Subject: **Contract DE-AC05-91OR21950**
MAYWOOD - FINAL MAYWOOD GROUNDWATER SAMPLING AND ANALYSIS PLAN

GROUNDWATER SAMPLING AND ANALYSIS PLAN FOR THE MAYWOOD SITE

**COMMENTS AND RESPONSES ON
THE GROUNDWATER SAMPLING ANALYSIS PLAN FOR THE MAYWOOD SITE
MAYWOOD, N. J. (October 1996)**

| Comments received 11/13/96, Angela Carpenter (USEPA) | | | |

Figure 1-17. Offsite Decision Rules for Onsite and Offsite Field Activities

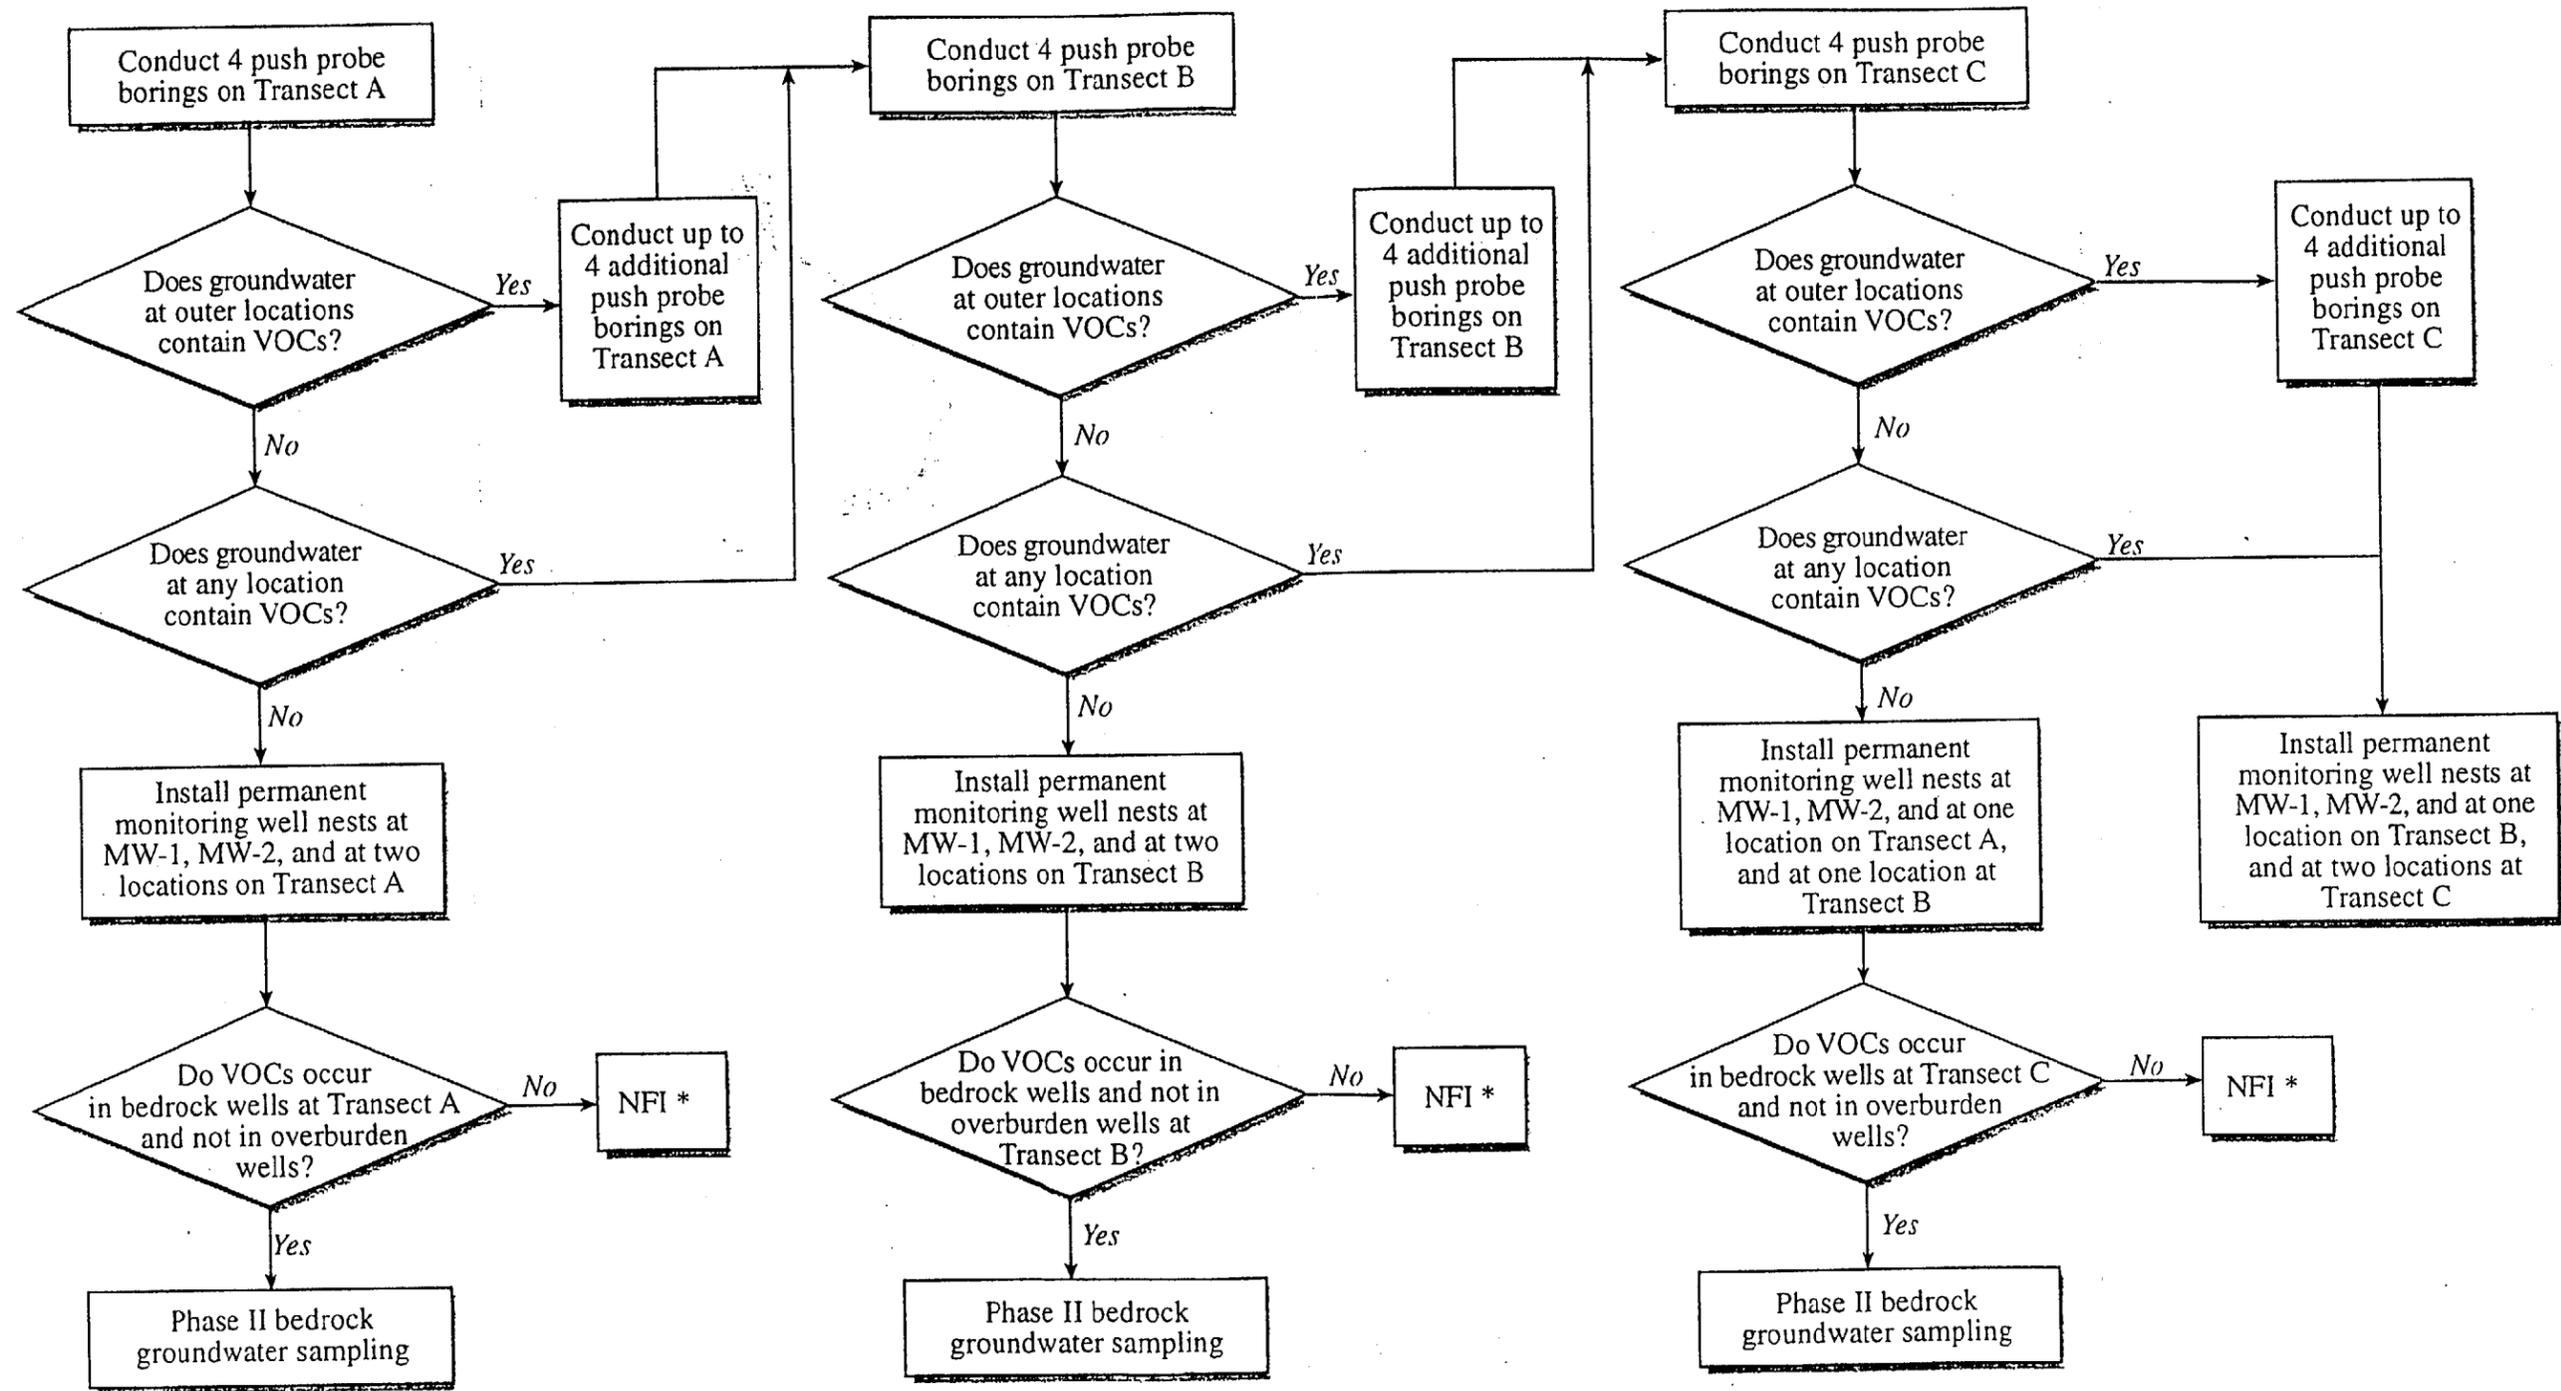
| COMMENT NO. | pp/§/¶ | COMMENT | RESPONSE |
|-------------|------------------------------------|--|--|
| 5 | Fig. 1-17. Off-site Decision Rules | The flow chart indicates what will be done if VOCs are found in the bedrock wells and not in overburden wells in each of the transects, but does not address what will be done if contamination is found both in the bedrock and overburden wells (but not in the soil gas probes). Please address this potential scenario in the work plan. | <p>If groundwater contamination is detected in push-probes and wells, but not in soil gas analysis, then it will be concluded that the soil gas method is not suitable for tracking contamination in groundwater at this site. A similar conclusion can be made if soil contamination is detected in samples but not in the soil gas analysis.</p> <p>The strategy for site investigation has been derived to ensure that the nature and extent of VOC contamination in groundwater is defined in a cost effective manner. If VOC contamination is found in both overburden and bedrock monitoring wells during this investigation, then it is expected that the configuration of wells outlined in this SAP will define the extent of contamination. Thus the goal of the sampling will be fulfilled. Further sampling will only be needed if, on analysis of the results, the extent of contamination is not defined. We feel that this occurrence is unlikely based on the amount of sampling proposed, however, the SAP does include Phase II sampling in the unlikely event that further sampling is needed after completion of Phase I sampling.</p> |
